**Comanche Peak
Nuclear Power Plant
(Vistra Operations
Company LLC)**
P.O. Box 1002
6322 North FM 56
Glen Rose, TX 76043

CP-202200358
TXX-22074
September 14, 2022

Subject: Comanche Peak Nuclear Power Plant (CPNPP)
Docket Nos. 50-445, 50-446 and 72-74
Transmittal of Revised Emergency Plan (Revision 46)

Comanche Peak Nuclear Power Plant Emergency Plan Revision 46 (Effective September 1, 2022)

TABLE F.1

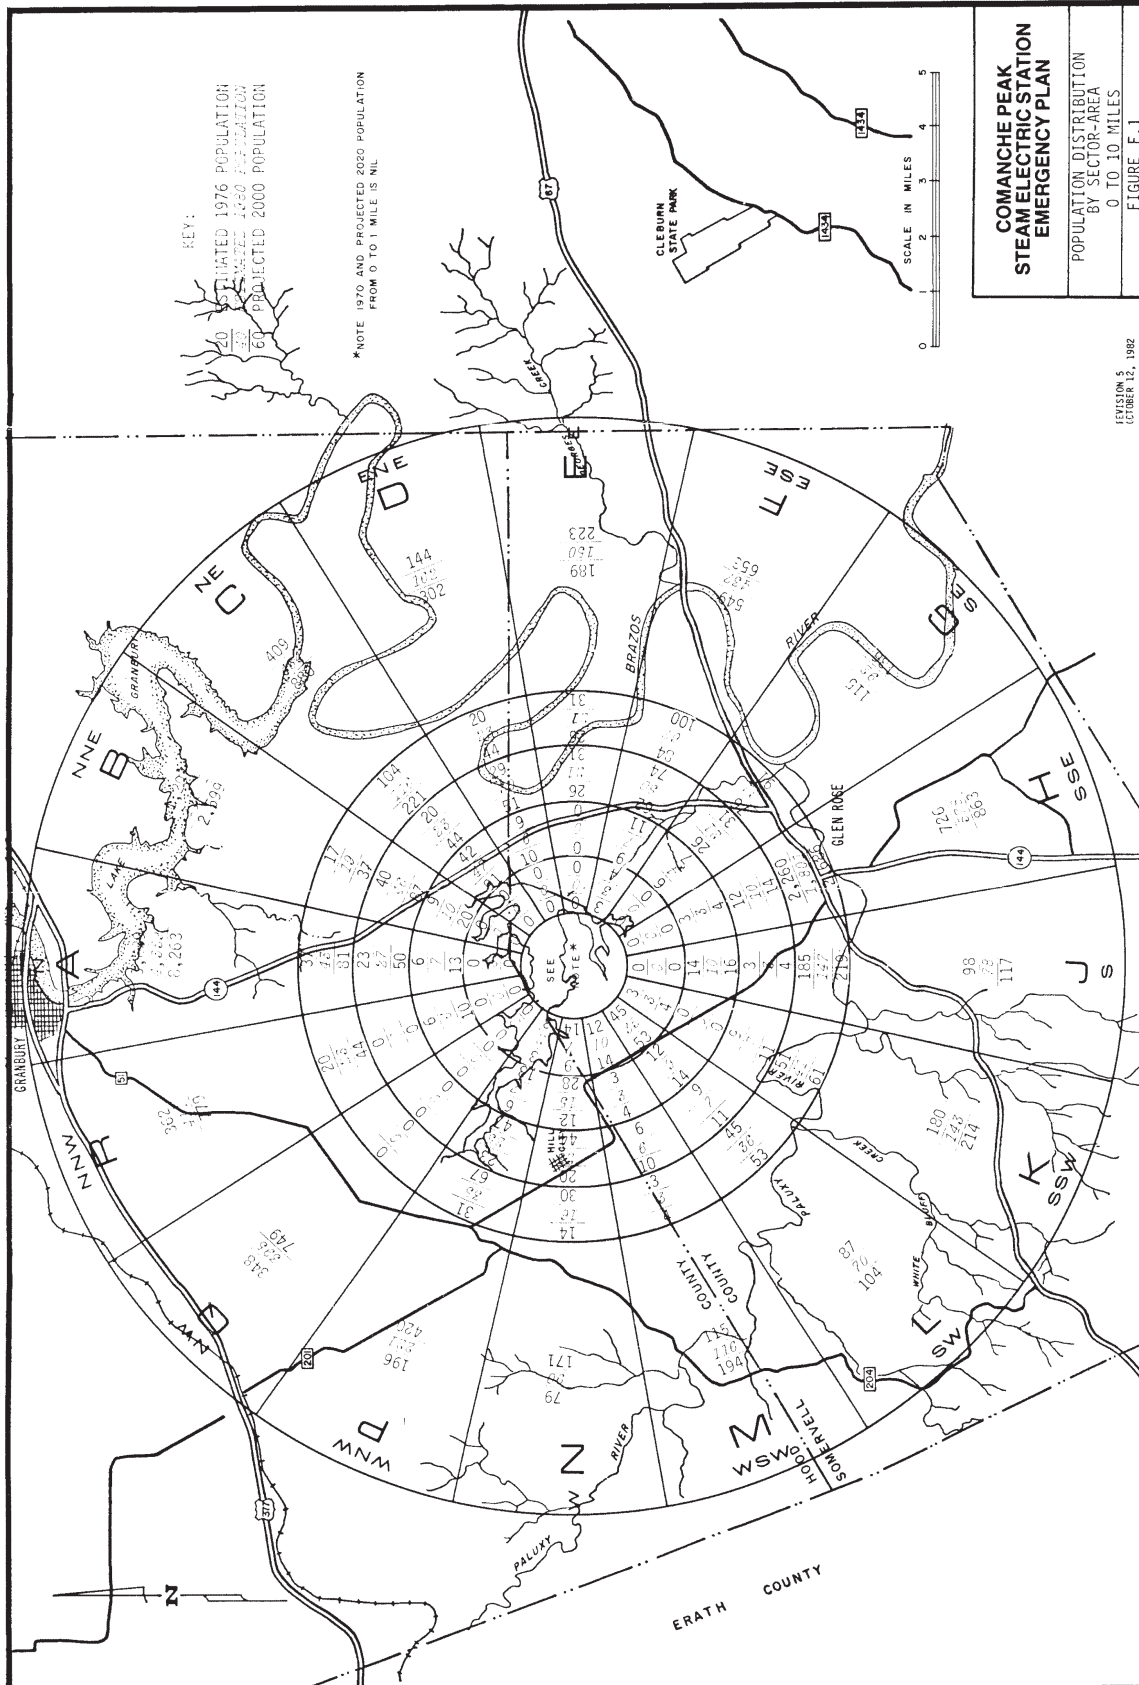
Revise Appendix F/Table F.1, Appendix M and Appendix N of the CPNPP E-Plan to update the summary information of the evacuation time estimate analysis (ETE) results to reflect changes to the ETE based on the 2020 decennial census results:

- Appendix F/Table F.1 was revised to add the 2020 populations by sector and area.
- The percentages of where the majority of ERO members live was updated in Appendix M.
- The evacuation time estimate analysis summary in Appendix N was revised based on the updated information from the 2022 CPNPP ETE.
